Re: Storm Water Inspection at Perimeter Retail Development/ Franklin County, Permit Number: 4GC04080*AG

This letter is written in follow up to a construction storm water inspection by Elizabeth Pleta and Jerome Hoke, of the Ohio EPA, at Perimeter Retail Development located at 6566 Perimeter Drive on September 17, 2013. The purpose of the inspection was to evaluate compliance with Ohio EPA's General Storm Water Permit Associated with Construction Activities. During the inspection, we noted the following:

Figure 1 Overburdened silt fence on south side of site.

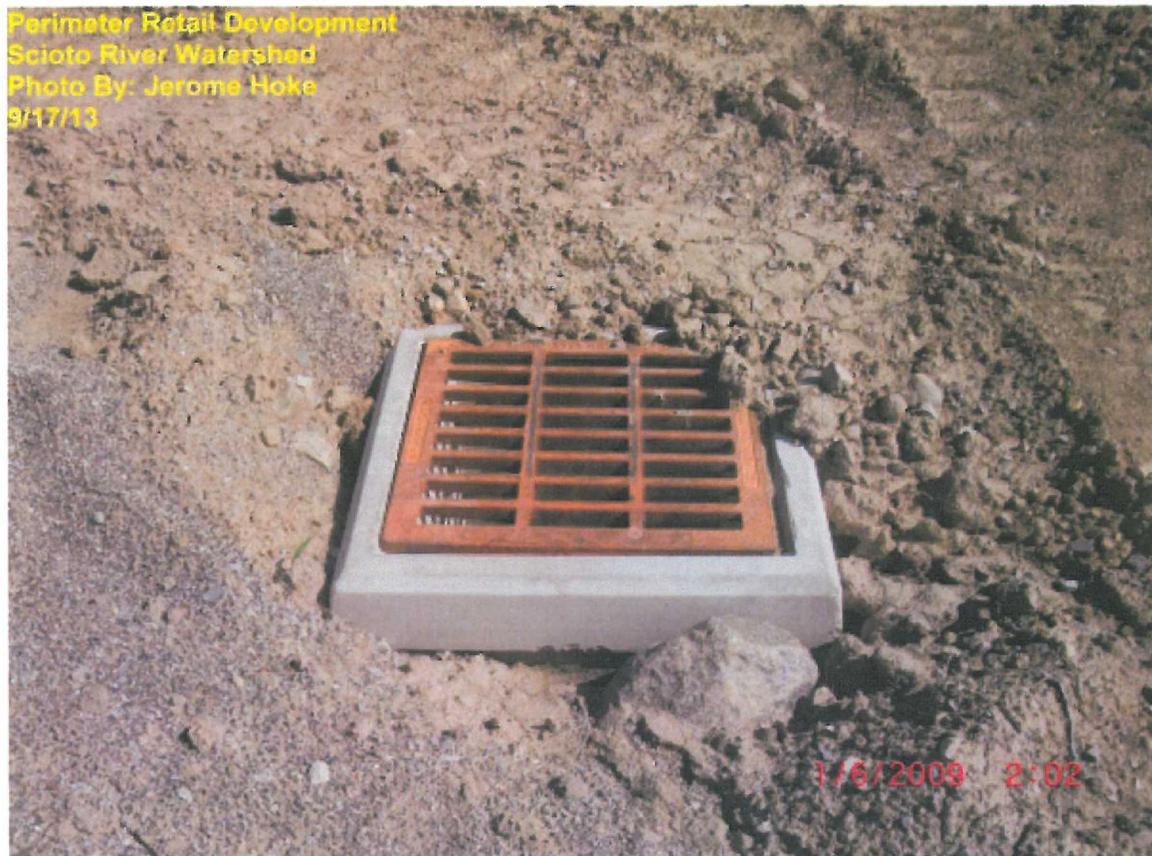
- It appears the perimeter silt fence on the south side of the site has become overburdened and will require maintenance within three (3) days of receiving this letter (See Figure 1).
- The inlets on this site lack proper protection (See Figure 2). Inlet protections are required for this site and must be installed within three (3) days of receiving this letter.
